PacifiCorp - Stakeholder Feedback Form

2021 Integrated Resource Plan

*Organization: Oregon Public Utility Commission

***IRP Topic(s) and/or Agenda Items:** List the specific topics that are being addressed in your comments.
July Public Input Meeting

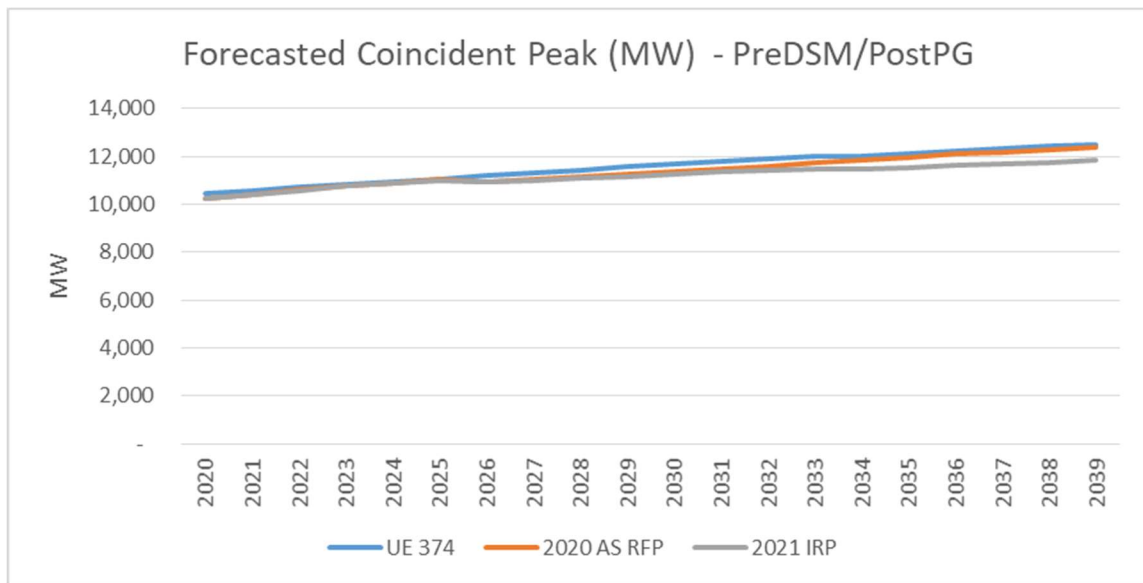
- Please provide a chart showing a comparison of the load forecast in the UE 374 rate case, the updated load forecast used in the 2020AS RFP, and the current load forecast for the 2021 IRP.

Please refer to the figure below, which compares the coincident peak forecasts used in the requested filings. Of note, the forecast results presented are representative of forecasted loads before accounting for the DSM program impacts and after accounting for private generation impacts.

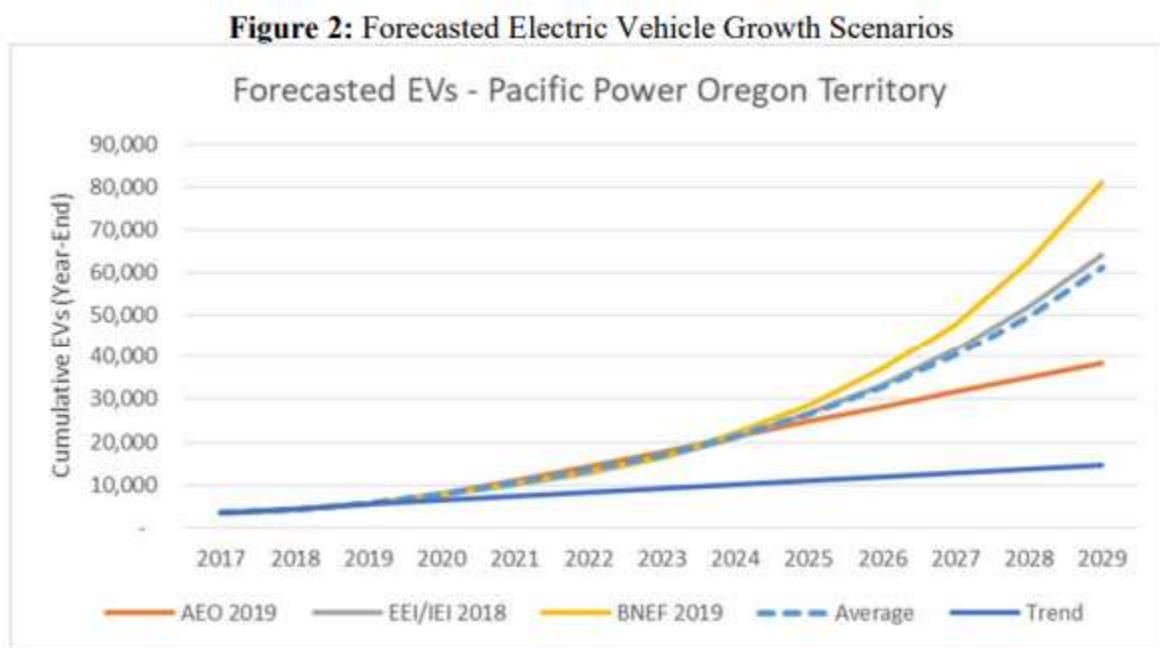
- In Figure 2 of PacifiCorp’s UM 2056 reply comments, the sources averaged to produce an EV growth rate grew faster than the EV adoption ‘trend’ in PacifiCorp’s Oregon service territory. What evidence suggests the EV growth rate in PacifiCorp’s Oregon service territory will become as high as an average of the AEO, EEI, and BNEF forecasts?

Figure 2 relates to how electric vehicles (EVs) were forecasted for the 2020 Transportation Electrification Plan in Oregon, but was not the source for forecasting EV load growth in the 2021 IRP load forecast. The EV projections used in the 2021 IRP load forecast were developed in April 2020 and were based on current and expected electric-vehicle adoption trends at that time. These projections were incorporated as a post-model adjustment to the residential and commercial sales forecasts.
